THE STAR

Modification 14 | Responses to Stakeholder
Comments on Transport Issues

2 March 2017

Figure 1: Coach Parking on Service Road Ramp

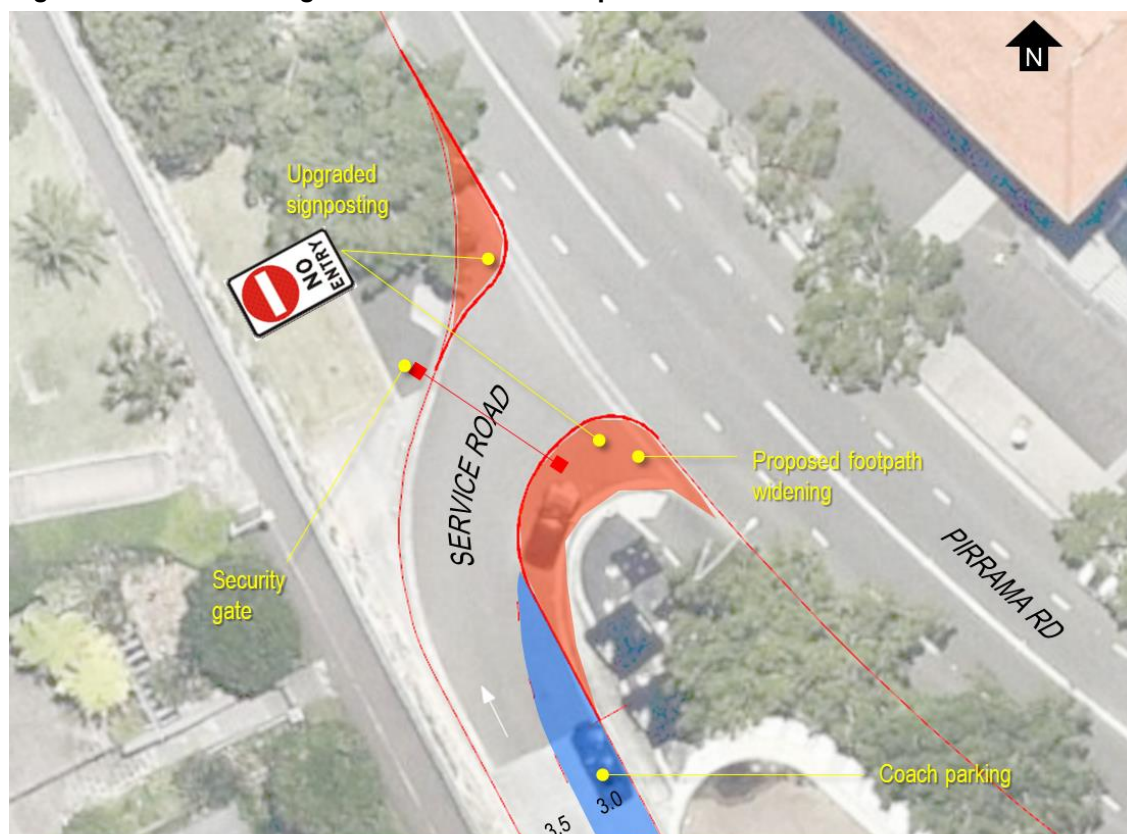
“Provide parking for buses which are larger than the standard mini-bus within the site or on adjoining streets which do not operate public bus services; and Identify and implement measures to ensure these buses do not park on Pirrama Road.”

Alternatively, there is an opportunity to provide 50m of coach parking on the service road exit ramp up to Pirrama Road. This ramp is currently signposted 'No Parking, Tow-away Zone'. However, local commuters are ignoring the 'No Entry' signs and parking restrictions and are illegally accessing and parking on the ramp. This creates operational problems for SEGL who may need this kerb space for special event storage or event parking.

- The conversion of the No Parking restrictions on the eastern side of the service road exit ramp to 'No Parking, Coaches Excepted, 6am to 6pm'
- Localised footpath widening at the exit to Pirrama Road and provision of a security boom gate and associated signage to physically restrict illegal car entry from Pirrama Road (refer Figure 1)
- Security monitoring to deter/move illegal parking

The proposed 50m of coach parking on the service road exit ramp could accommodate 3-4 large on-site coach spaces or 5-6 mini-bus spaces. The proposed footpath widening would still permit coaches to turn right onto Pirrama Road, to return to the interchange for the passenger pick-up. Any excess coach parking demand would be directed to the formal on-street facilities in Pirrama Road or the CBD.

Figure 7: Proposed Pyrmont Parking Guidance Scheme

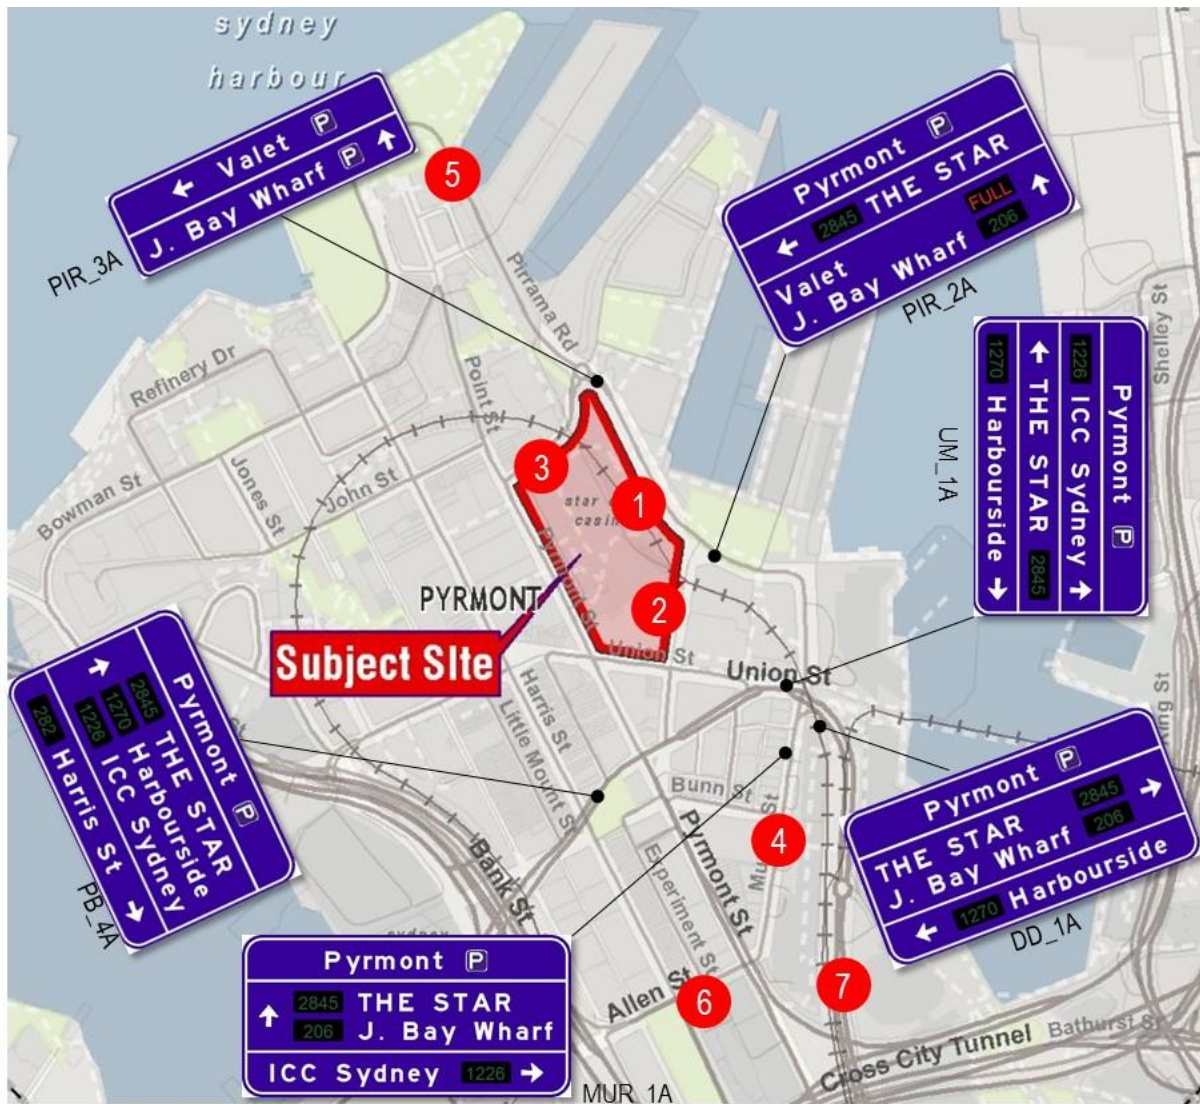
“TfNSW requests that the applicant prepares a detailed parking and loading bay management plan in consultation with CCO within TfNSW, prior to issuing the Construction Certificate. The Plan should include details on how the Pymont Parking Guidance System could be improved, who will replace it and the system to be established by The Star to operate it...(TfNSW)”

In response to stakeholder comments, Modification 14 will now propose the following upgrades to the Pyrmont Parking Guidance System (PPGS) as outlined in Figure 7 below:

- SEGL will work with TfNSW and Parking Sense to upgrade the Pyrmont Parking Guidance System;
- SEGL to provide data feed to Parking Sense, and mobile parking apps, to continually update signage displays
- SEGL to contribute to upgrade costs of the system and lead resolution of the proposed signage

Figure 8: Proposed Changes to the Port Cochere

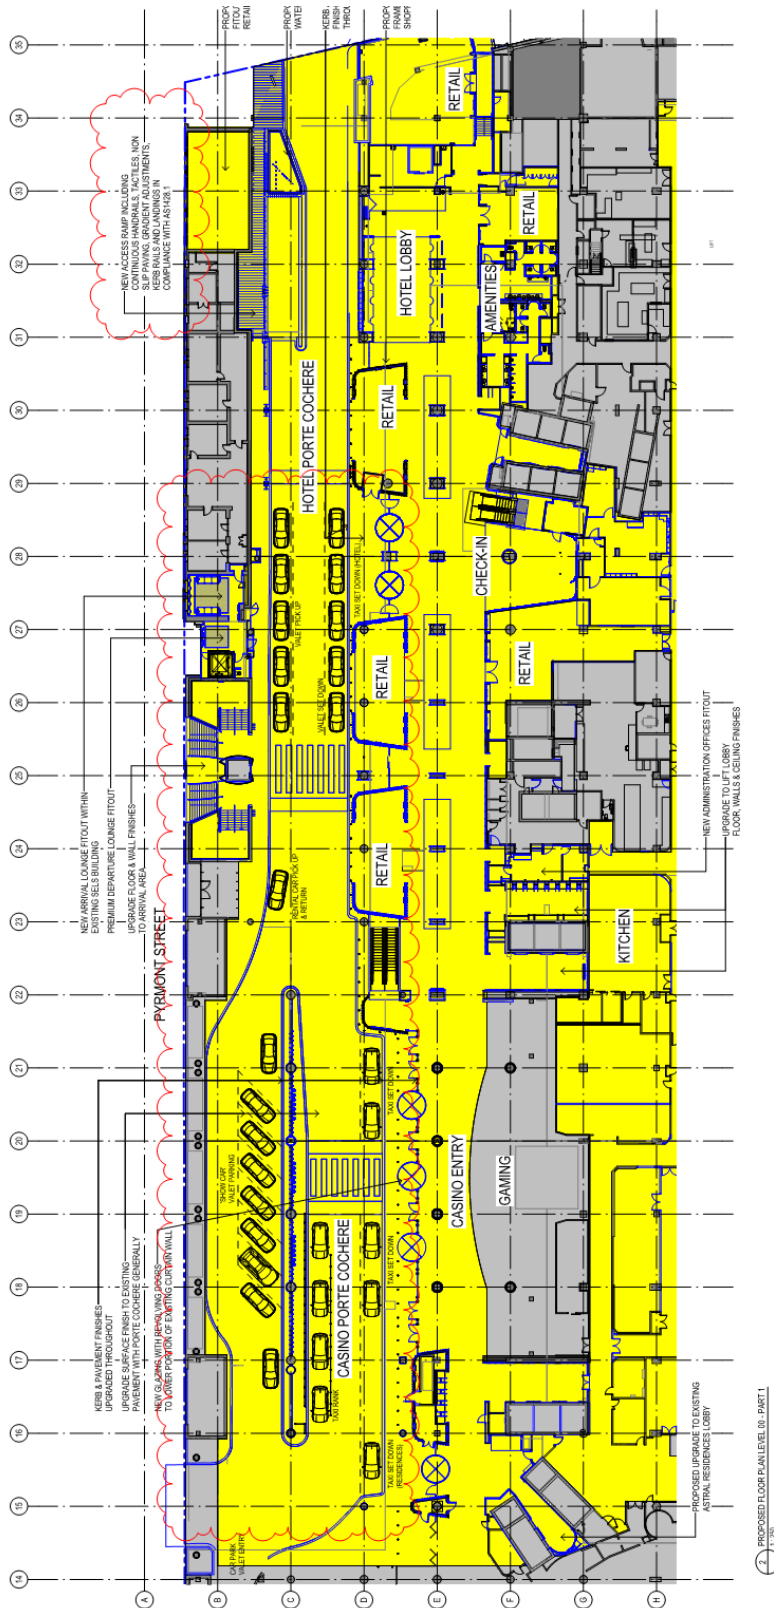
“..details how the redesigned Port Cochere will achieve the following:

- *Addresses the existing operation issues; and*
- *Accommodates the forecast increased usage..” (CoS)*

Operations in the Port Cochere will not be significantly changed by Modification 14. Taxis, limousines, valet service and hire cars will continue to operate out of the Port Cochere, as they currently do, however, waiting areas for each will become more formalized (refer Figure 8).

The existing pick-up zone immediately outside the Casino entry has been reduced from 3 to 2 spaces, due to the installation of escalators as part of D2015/1515, and will be converted to a taxi drop-off-only zone in Modification 14.

However, the valet service and taxis could accommodate additional demands should it eventuate. SEGL is proposing to increase resourcing of the valet service to ensure quicker dispatching of vehicles. Also, SEGL is proposing an increase in the number of taxi bays in the Port Cochere (refer Figure 2) during peak times, to include:

- 3 taxi set-down/pick-up bays in front of the Astral Hotel entry
- 2 taxi set-down bays at the Casino entry
- 6 taxi pick-up bays and patron queuing system at the Casino entry
- 1 taxi set-down/pickup bay at the Residences

Figure 9: Level B2 Cycle Parking Proposal

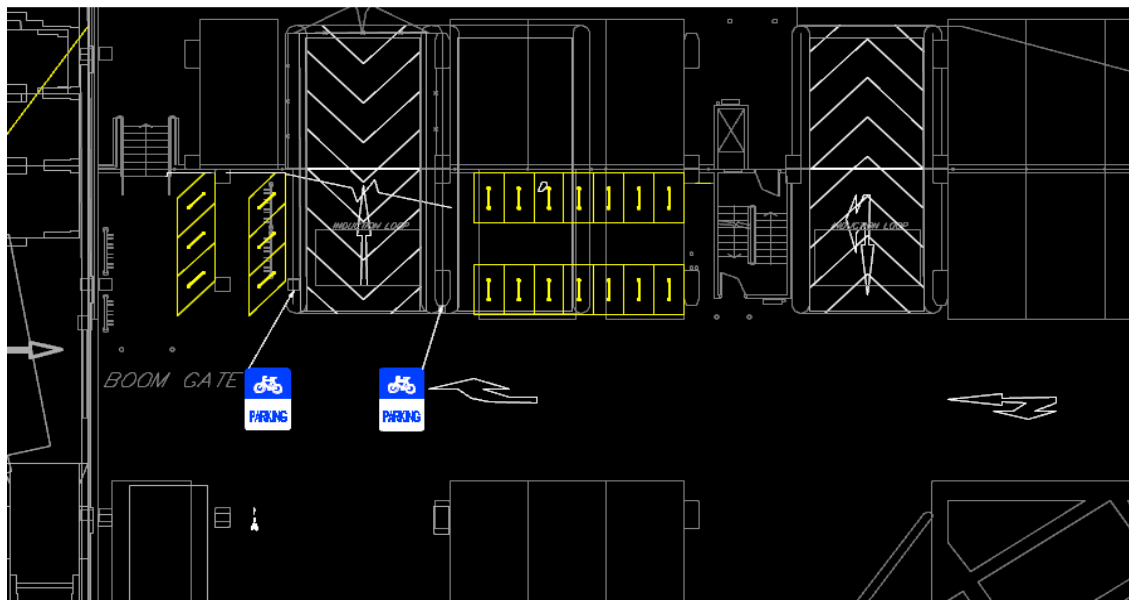
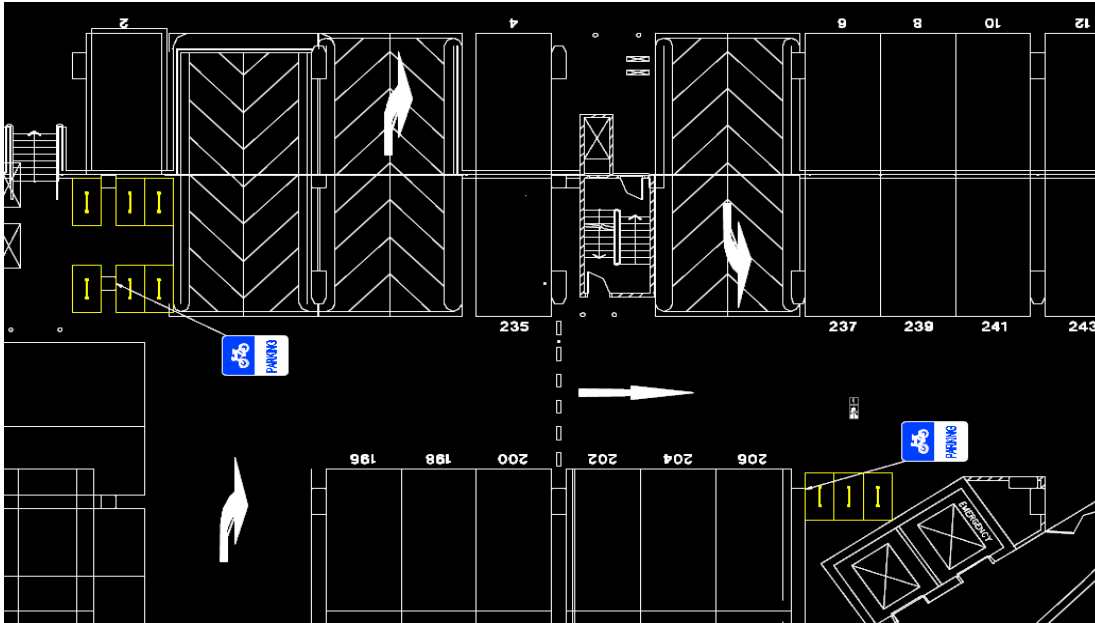
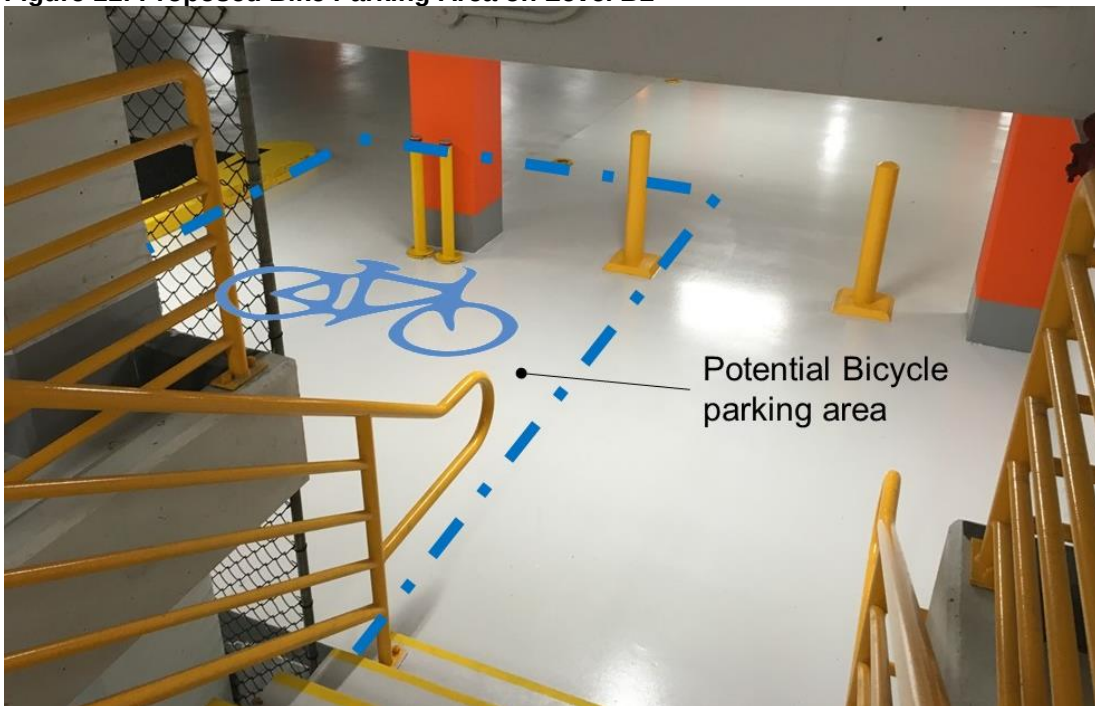
“In accordance with the Sydney DCP, the provision of 1 bicycle parking space per 10 staff and 1 bicycle parking space per 40m² GFA should be appropriate. Staff parking should be class 2 facilities (known as Class ‘B’ in the latest Australian Standards) and provided as per AS2890.3:2015, and be located at an accessible at-grade location in a separate location to the visitor parking area...” (CoS)

The suggested rate of 1 parking space per 40sqm GFA seems excessive and more appropriate to high density visitor uses such as theatres and places of workshop. This high rate also usually excludes additional provisions for employees.

A shopping centre based rate of 1 space per 300sqm GFA, seems more appropriate in this instance. The additional 6,633 sqm GFA would yield a requirement for 22 Class 3 visitor parking spaces. Sample layouts have been prepared for up to 29 spaces located across the Level B1 and B2 car parks to be installed as part of Modification 14 (refer Figures 9 & 10).
